A450NX MP Server Board Set

Specification Update

Order Number 245005-010
July, 2000 Edition
Enterprise Server Group

Figure 1 - Configuration Jumper Block (J3H1)

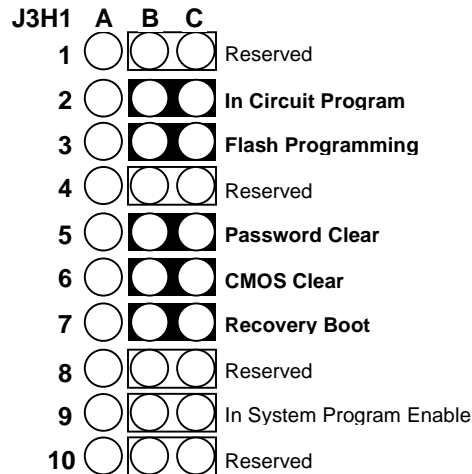
The AD450NX MP Server System Product Guide does not correctly represent the I/O board configuration jumpers in table 17-1 on page 233. Password Clear, CMOS Clear and BIOS Recovery are listed as pins 6, 7 and 8. They should actually be pins 5, 6 and 7 respectively, as indicated in the diagram below. However please note that the A450NX Board Set Technical Product Specification has the same jumper block diagram for the I/O board and all jumpers are correctly labeled. Please reference this diagram on page 2-13 of the board set TPS as well as below.
